BEFORE COMMISSIONER MARK ST. CLAIR APPOINTED BY NEW PLYMOUTH DISTRICT COUNCIL

of the Act by **ROBE AND ROCHE INVESTMENTS LIMITED** to the **NEW PLYMOUTH DISTRICT COUNCIL** for a subdivision to
create 113 residential lots and
additional road and recreational
reserves at 56 Pohutukawa Place,

JOINT WITNESS STATEMENT

AMENDMENDED SUBDVISION SCHEME PLANS

APPENDIX 1 – AMENDED SCHEME PLAN

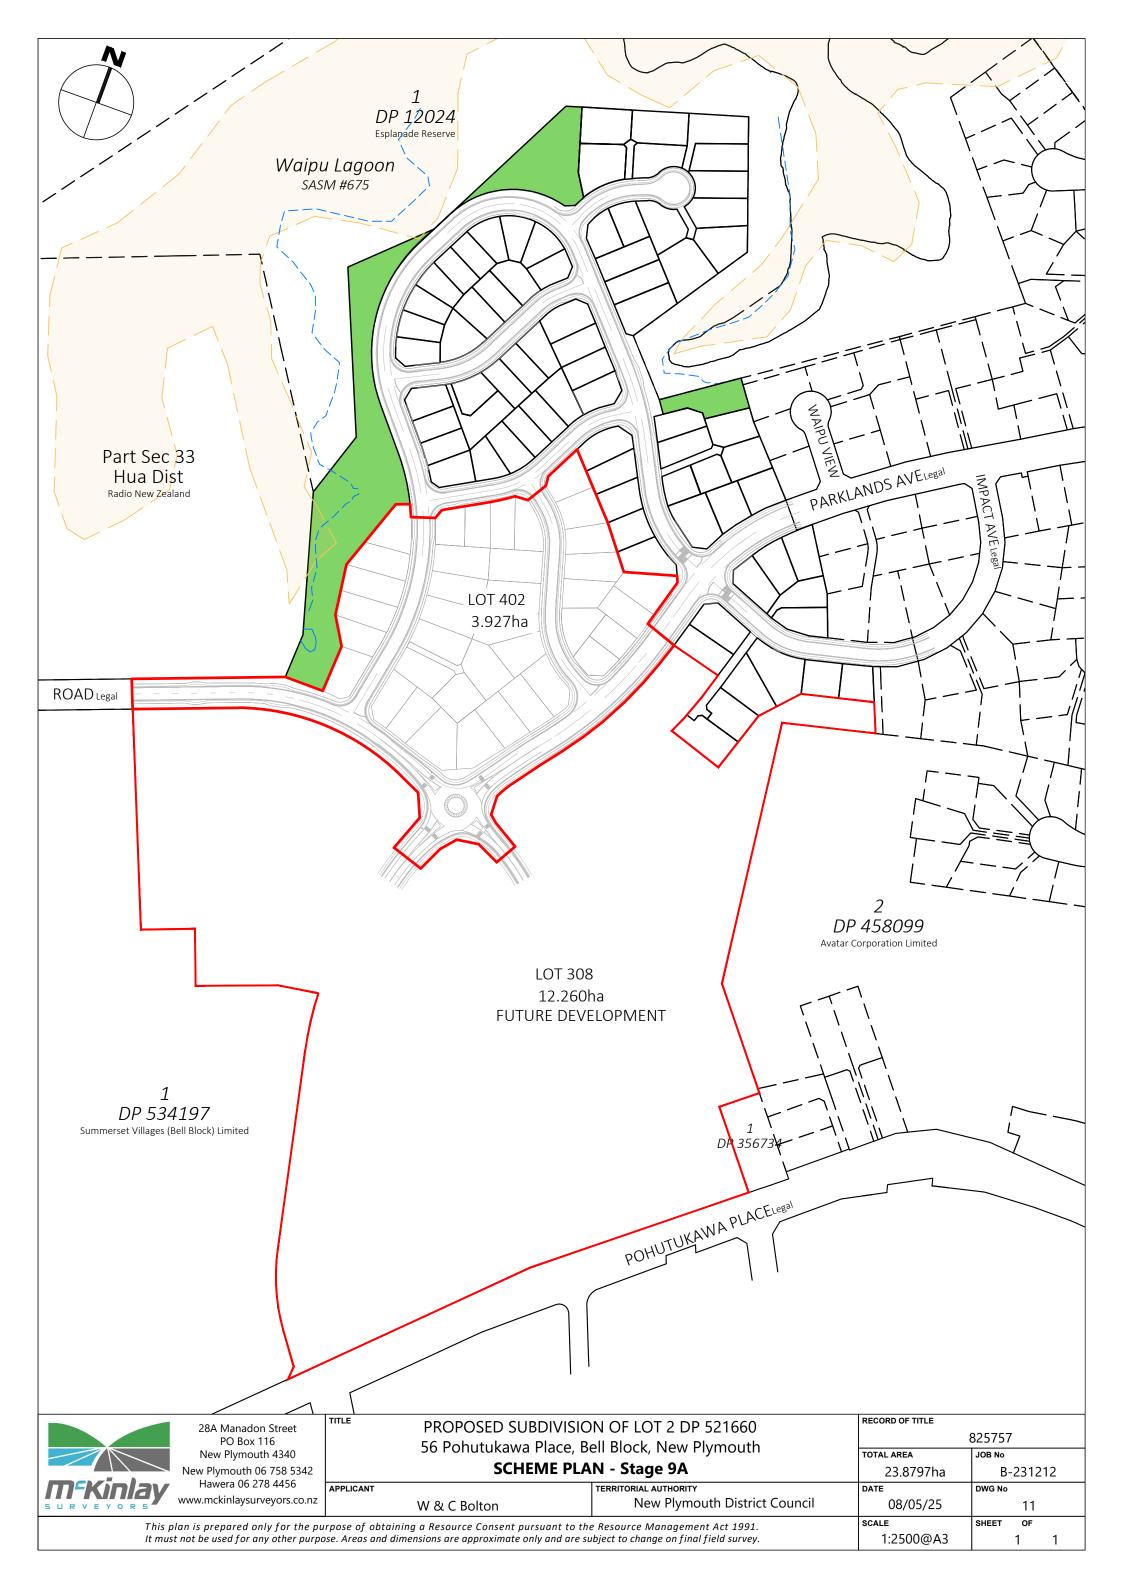
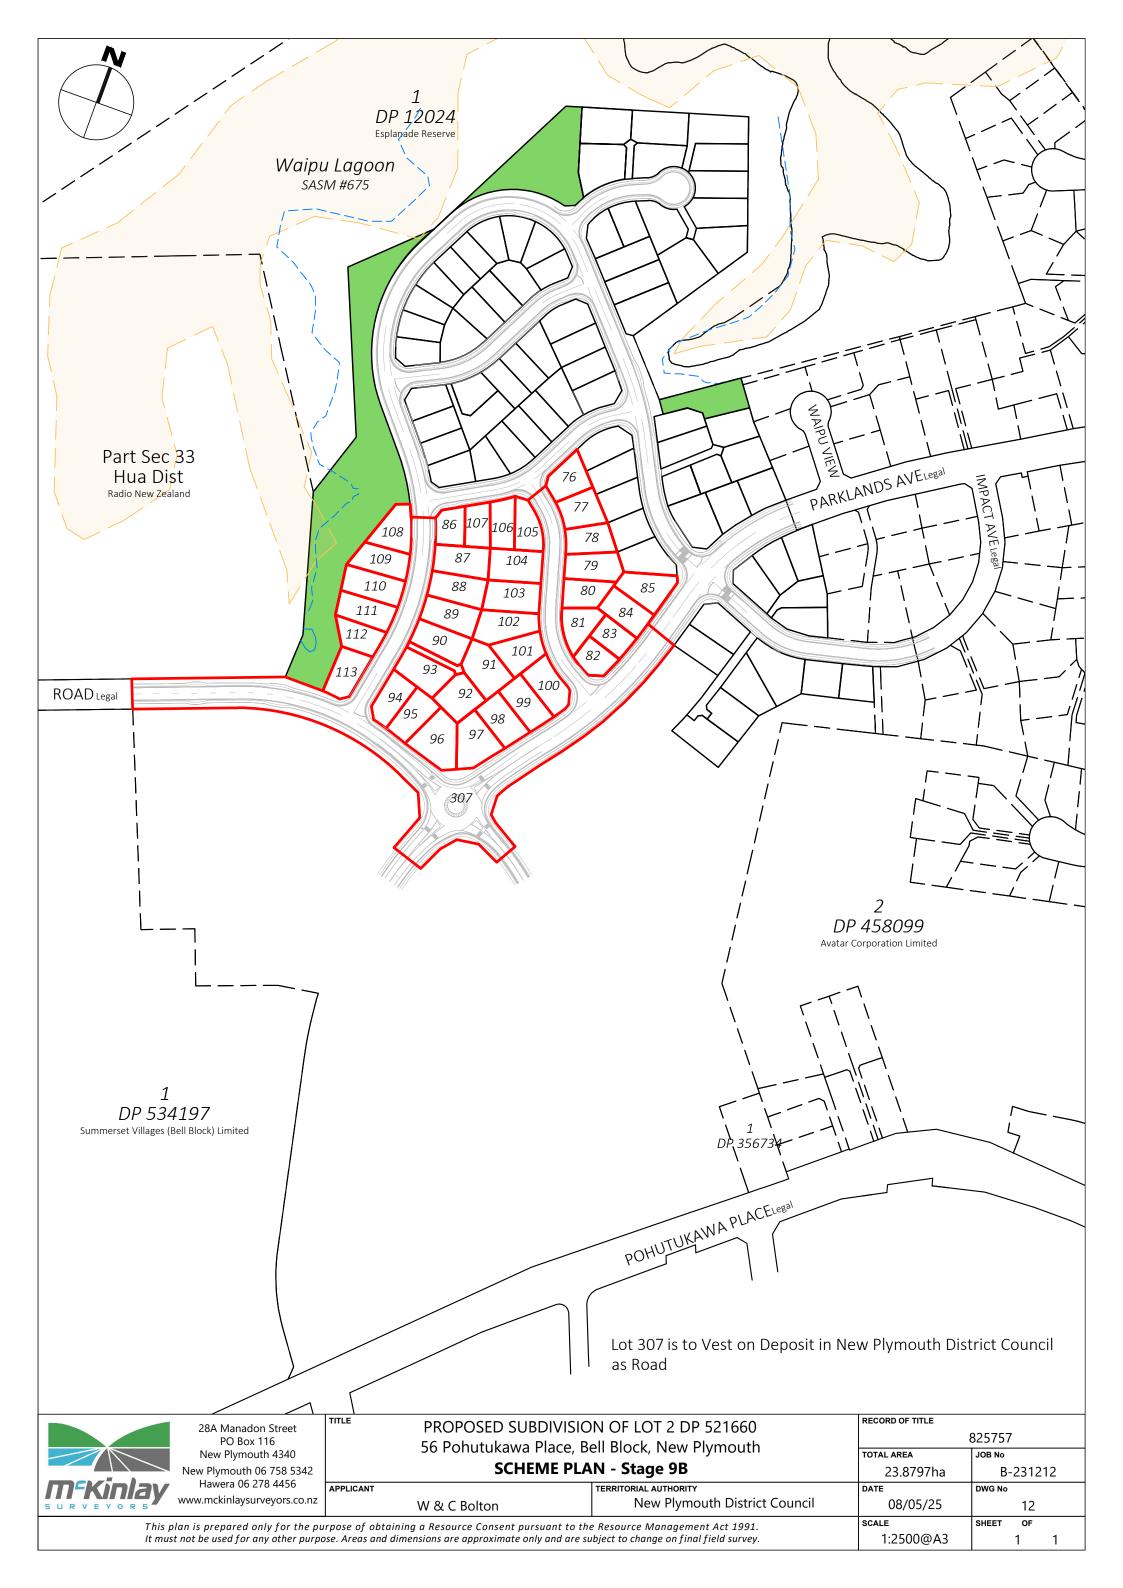
- (a) Roading Changes
 - (i) The initial roundabout shown on the scheme plans for Road 1, Road 2 and Impact Ave has been modified to be two intersections instead. This was following the initial draft consent condition which included an advice note stating "Access to Lots 36, 37 and 76 will need careful consideration regarding location, due to the splitter islands and separation from roundabout."

- (ii) Following review from Red Jacket Engineering, in discussion with NPDC Roading Team, it was agreed that a roundabout in this location was not appropriate and would create unintended access and visibility issues with the residential lots adjoining it.
- (iii) The two intersections to replace the roundabout has been designed by Red Jacket Engineering and reviewed by the NPDC Roading Team who are accepting of the design which will alleviate the advice note requiring consideration on the access to the adjacent residential lots. The advice note has subsequently been removed from the draft consent conditions.

- (c) Subdivision Stages and Numbering
 - (i) Discussions have taken place during the drafting of consent conditions on the staging requirements for the subdivision, with amendments to include infrastructure, financial and cultural reasonings.
 - (ii) The altered subdivision scheme plan has included the following changes:

- Stage 6A Lot 400 and Lot 403 (Superlots);
- Stage 6B Lots 1 28, Lots 301 303 (Reserve) and 304 (Road);
- Stage 7 Lots 29 49 and Lot 305 (Road);

Figure 3: Initial Lot 301

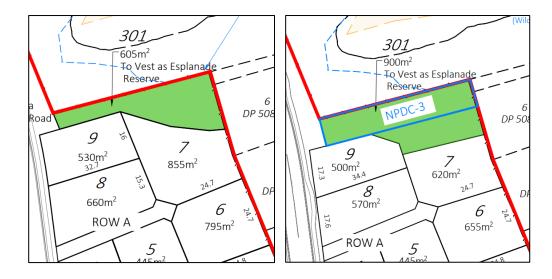
- (b) Adjustment of Lot 301 Esplanade Reserve
 - (i) Following the discussion of the Designation 'NPDC-3' process for Lot 301 at the hearing, the Designation area was overlaid on the scheme plan and agreed that Lot 301 needed to be widened to encompass the entire Designation overlay.
 - (ii) The Esplanade Reserve Lot 301 has been widened in the amended scheme plan and increased in size from the initial 605m² to 900m², which allows for the Designation to be wholly contained within Lot 301. The adjoining residential Lots 6, 7, 8 and 9 have subsequently reduced slightly in size, however, are all still above the minimum allotment size of the ODP or PDP.
